Subject: UniStar Nuclear Energy, NRC Docket No. 52-016
Response to Request for Additional Information for the
Calvert Cliffs Nuclear Power Plant, Unit 3,
RAI 384, Fire Protection Building Ventilation System

**Response to NRC Request for Additional Information
RAI 384, Question 09.04.03-1,
Fire Protection Building Ventilation System,
Calvert Cliffs Nuclear Power Plant, Unit 3**

RAI, Section 9.4.16 Fire Protection Building Ventilation System

**Changes to CCNPP Unit 3 COLA
Associated with the Response to RAI 384, Question 09.04.03-1,
Calvert Cliffs Nuclear Power Plant, Unit 3**

Figure 1

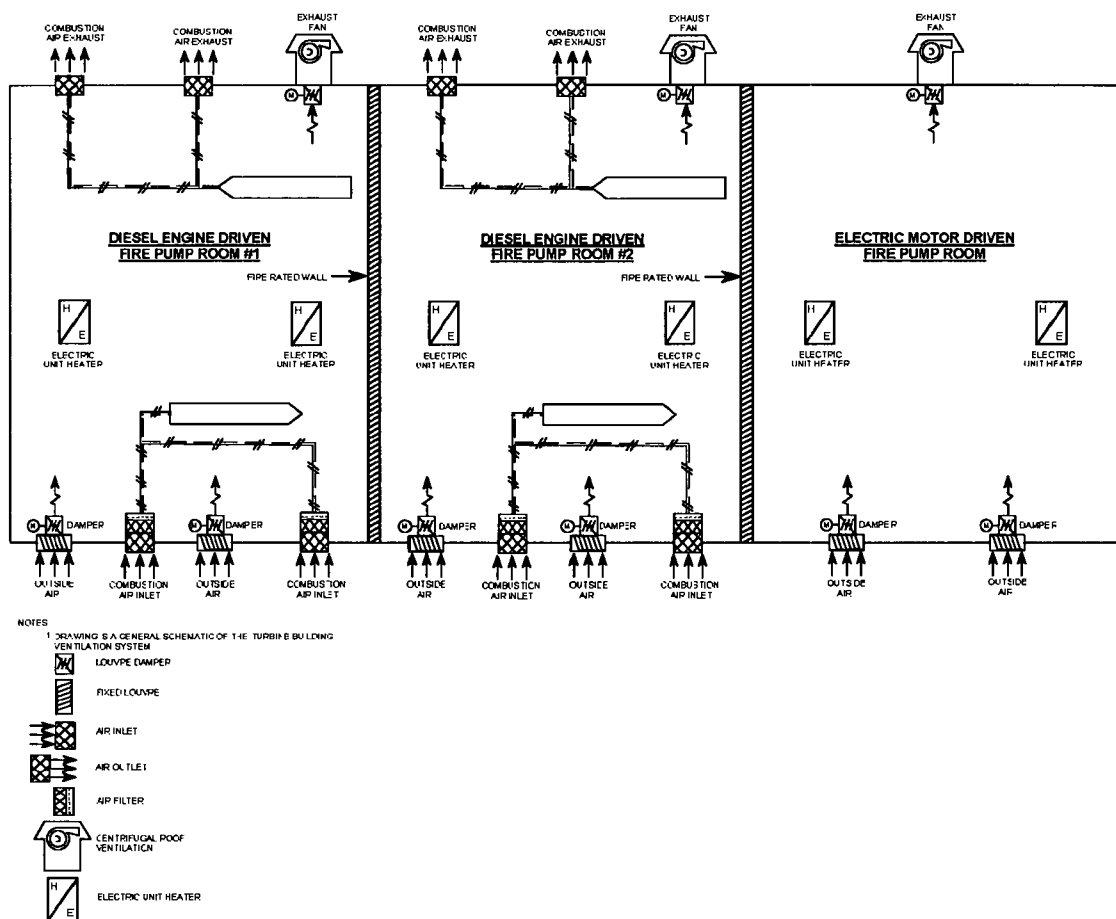
Also provide a system flow diagram or piping and instrument diagram of FPB Ventilation System showing the key features of major components.

The Fire Protection Building Ventilation System provides an acceptable environmental condition for the operation of the Fire Protection System Equipment, including the diesel engine driven pumps located inside of the Fire Protection Building (FPB). Figure 9B-20, CCNPP Unit 3 Fire Barrier Location, Fire Protection Building Plan View at Elevation 85'0, provides schematic representation of the Fire Protection Building. This figure is updated to be consistent with the general arrangement fire protection storage tanks and buildings drawing. Figure-1 depicts the Fire Protection Building Ventilation System components. This ventilation system also provides safe and satisfactory indoor environmental conditions to support personnel access to the two diesel driven pump rooms and electric motor operated pump room. The Fire Protection Building Ventilation System, in the two diesel engine driven pump rooms, is a Nonsafety-Related augmented quality (NS-AQ) system designed to meet Conventional Seismic-I requirements. The ventilation system in the electric motor driven pump room is a Non-Seismic system. Each pump room contains independent components of the ventilation system to maintain the temperature in their respective rooms.

In the event of loss of offsite power (LOOP) or Station Blackout (SBO), a self-contained Standby Diesel Generator (SDG) provides AC power supply to the FPB ventilation system, heating system, and building normal and emergency lighting systems to the two diesel driven fire pump rooms. The SDG is a Nonsafety-Related augmented quality system designed to meet the Seismic requirement of Conventional Seismic-I. The SDG will be functional and provide power to the FPB ventilation system, heating system, and building normal and emergency lighting systems after a seismic event and loss of power to FPB. Based on the day tank fuel capacity, the Standby Diesel Generator will be able to provide power for up to 24 hours to maintain FPB room temperature within the design limits. The SDG is required to operate a minimum of 8 hours upon total loss of AC power to the FPB and when the diesel fire pump is running, to supply water to mitigate fire in accordance with the requirement of RG 1.189, Section 3.2.2.

Figure 9B-20— (CNPP Unit 3 Fire Barrier Location, Fire Protection Building Plan View at Elevation 85'0")

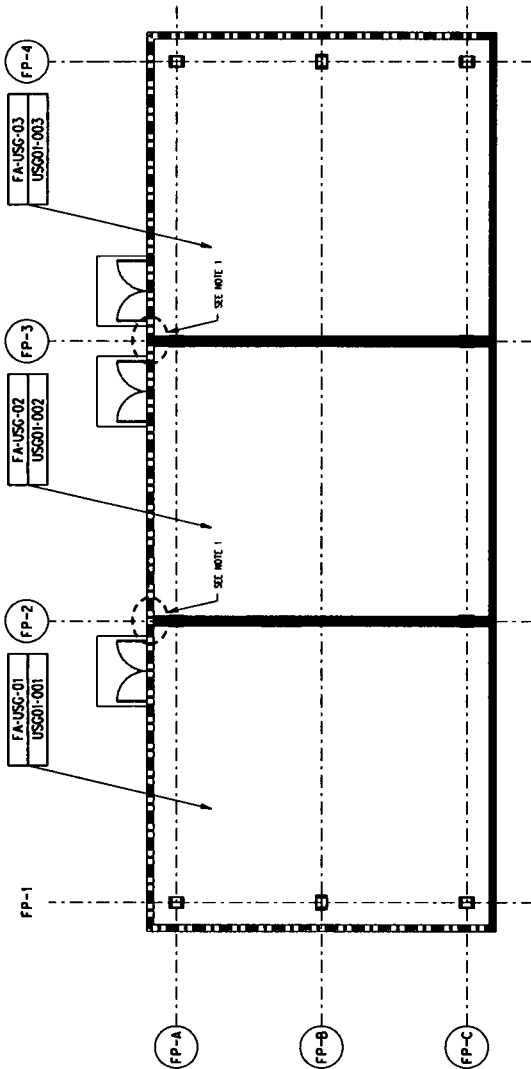
In FSAR, Revision 8, Section 9.4.16, it is indicated that in the event of Loss of Offsite Power or in the event of Station Blackout, the emergency power system is supplied to the Fire Protection Building (FPB) Ventilation System to the two diesel engine driven pump room components to maintain the normal room design temperature conditions. This is to meet the requirements of RG 1.189 Section 3.2.2 for the diesel engine driven pump operation.

INSERT G

CC3-13-0077	9.4.16.1, 9.4.16.2.1, 9.4.16.2.3, 9.4.16.3, 9.4.16.4, 9.4.16.6, Table 9B-2, Appendix 9B, Figure 9B-20	Incorporate COLA markups associated with the response to RAI 384.	Requirements for the Standby Diesel Generator for the Fire Protection Building Ventilation System as part of RAI 384 Q 02.05.01-70.
CC3-13-0077	14.2.14.14	Incorporate COLA markups associated with the response to RAI 384.	Requirements for the Standby Diesel Generator for the Fire Protection Building Ventilation System as part of RAI 384 Q 02.05.01-70.
Part 10 – ITAAC			
CC3-13-0031	2.4-9 Item 1	Incorporate COLA markups associated with the submission of CCNPP Unit 3 COLA Rev 9 for consistency with U.S. EPR DC Rev 4 ⁶ .	Format and wording changes are made as part of the submittal of the CCNPP Unit 3 COLA Rev 9.
CC3-13-0077	2.4-9 Item 1	Incorporate COLA markups associated with the response to RAI 384.	New ITAAC parts are added for the Standby Diesel Generator for the Fire Protection Building Ventilation System as part of RAI 384 Q 02.05.01-70.
